RE: RICRMC File #2020-07-031

2 & 4 Shell Road Shared Dock

The attached plan set (dated November 6, 2023) was updated with the following revisions:

PROPOSED SITE PLAN MLWD

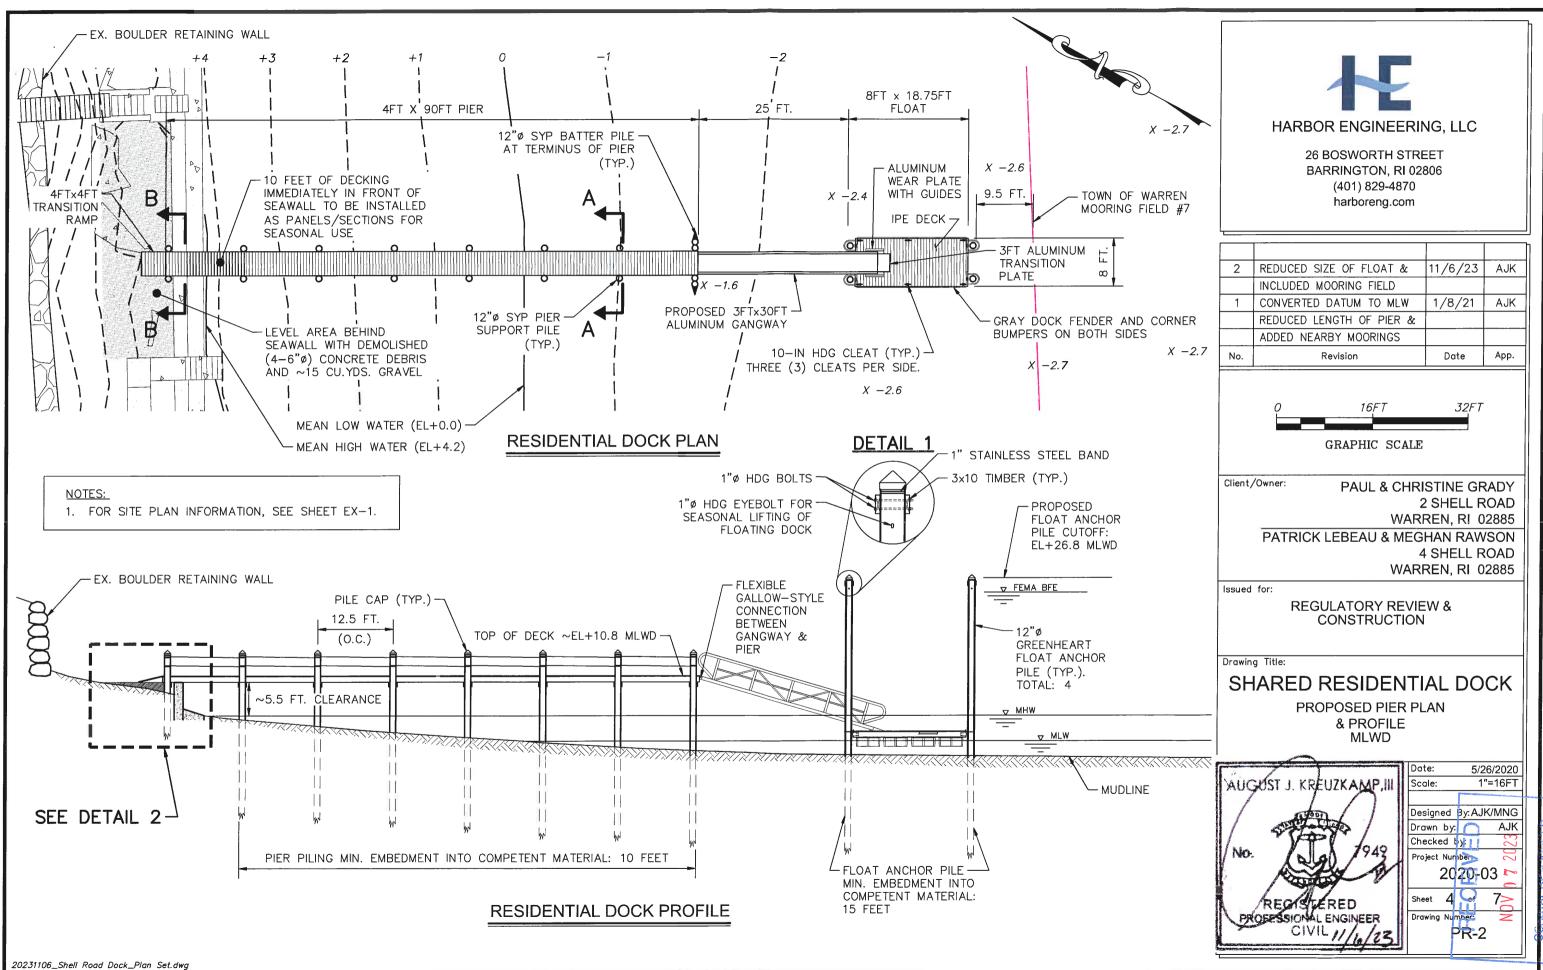
- Float area reduced to 150 sq.ft. with new dimensions 8ft x 18.75ft
- Town of Warren mooring field boundary and 50-foot setback
